| DOCKETED | | | |
|------------------|--|--|--|
| Document Title: | Gabel Energy Comments - 2025 Energy Code Update Rulemaking | | |

2025 Energy Code Update Rulemaking

Re: 2025 45 Day Title 24 Part 6 Energy Standards – 2nd Docketed Letter

When skylight is an exit passageway (Fire Code)

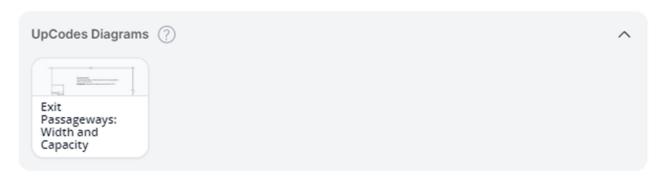
We have expressed a few times now our concern about not allowing any flexibility for fenestration U-factors when considering fire rated requirements, and WUI. Here are a few code sections supporting the requirements for fire-rated windows, glass doors and skylights.
